Access Compliance Report Public Rights-of-Way (Pedestrian Signals)

Main Street: **IRVINE_BLV** Cross Street: **RED_HILL_AVE** Location: **NE**

ADA ID: **SGAT211021143746** Signal Type: **One Push Button-APS** Overall Compliance: **No** Severity Scores: **BTN 1: 35** **BTN 2: N/A** **No BTN: N/A**

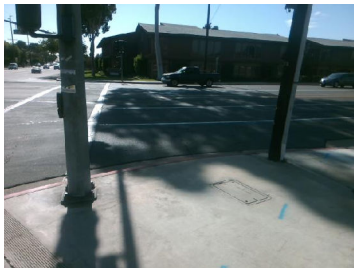
Compliance	Description	Data	Compliance	Description	Data
Button Count		Button1	Yes	Distant to Additional Button (in)	263
Additional Button Present?		Yes	N/A	Additional Button ID	SGAT211021143953
Located In An Island/Median?		No			
N/A B 1 Sign Present?		Yes	N/A	B 2 Sign Present?	N/A
Yes B 1 Sign Purpose?		Yes	N/A	B 2 Sign Purpose?	N/A
Yes B 1 Sign Lettering & Contrast?		Yes	N/A	B 2 Sign Lettering & Contrast?	N/A
No B 1 Parallel To XWalk?		No	N/A	B 2 Parallel To XWalk?	N/A
N/A B 1 PAR to Button?		N/A	N/A	B 2 PAR to Button?	N/A
N/A B 1 PAR to XWalk?		N/A	N/A	B 2 PAR to XWalk?	N/A
Yes B 1 Clear Floor Space?		Yes	N/A	B 2 Clear Floor Space?	N/A
N/A B 1 FWD Approach?		N/A	N/A	B 2 FWD Approach?	N/A
N/A B 1 FWD Approach Constrained?		N/A	N/A	B 2 FWD Approach Constrained?	N/A
N/A B 1 FWD Approach Reach (in)		N/A	N/A	B 2 FWD Approach Reach (in)	N/A
N/A B 1 FWD Approach Width (in)		N/A	N/A	B 2 FWD Approach Width (in)	N/A

N/A B 1 FWD Approach Obstruction?		N/A	N/A	B 2 FWD Approach Obstruction?	N/A
N/A B 1 FWD Approach Obstruction Dist (in)		N/A	N/A	B 2 FWD Approach ObstructionDist (in)	N/A
N/A B 1 PARA Approach?		N/A	N/A	B 2 PARA Approach?	N/A
N/A B 1 PARA Approach Constrained?		No	N/A	B 2 PARA Approach Constrained?	N/A
Yes B 1 PARA Approach Reach (in)		0	N/A	B 2 PARA Approach Reach (in)	N/A
N/A B 1 PARA Approach Width (in)		N/A	N/A	B 2 PARA Approach Width (in)	N/A
N/A B 1 PARA Approach Obstruction?		No	N/A	B 2 PARA Approach Obstruction?	N/A
N/A B 1 PARA Approach Obstruction Dist (in)		N/A	N/A	B 2 PARA Approach Obstruction Dist (in)	N/A
No B 1 Clear Floor Space Slope (%)		4.8	N/A	B 2 Clear Floor Space Slope (%)	N/A
Yes B 1 Clear Floor Space XSlope (%)		0.6	N/A	B 2 Clear Floor Space XSlope (%)	N/A
N/A B 1 PAR Slope (%)		0.9	N/A	B 2 PAR Slope (%)	N/A
Yes B 1 Height (in)		48	N/A	B 2 Height (in)	N/A
Yes B 1 Pressure (#)		5	N/A	B 2 Pressure (#)	N/A

Possible Solutions: Remove and Replace Clear Space.
